Issue 3

Are the strategic objectives and the strategic approach to housing delivery and economic development delivery in terms of distribution and location sound having regard to the needs and demands of the Borough, national policy and Government objectives and the evidence base and preparatory processes? Has the Local Plan been positively prepared?

Subject:FW: 15/00856/AS - Land at Pound Lane, Magpie Hall Road, Bond Lane and, Ashford Road, Kingsnorth, Kent

Application - 15/00856/AS

Figure 1 - Crash (accident data study area)

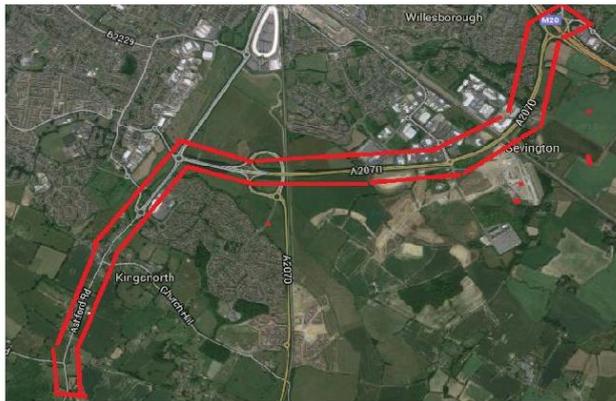
Crash data needs to be obtained for a wider study area than what is currently shown. As detailed in KCC Highways and Transportation previous consultation response on the application, the extent of crash data should be provided as shown in Figure 1 below. This is from the junction of Magpie Hall Road / Ashford Road / Steeds Lane to the junction of M20 Junction 10. Dialogue should also be undertaken with Highways England in respect of the Strategic Road Network. A section is needed within any amended supplementary Transport Assessment detailing any particular crash clusters (for example the junction of Magpie Hall Road / Ashford Road / Steeds Lane and Pound Lane / Church Hill / Ashford Road).
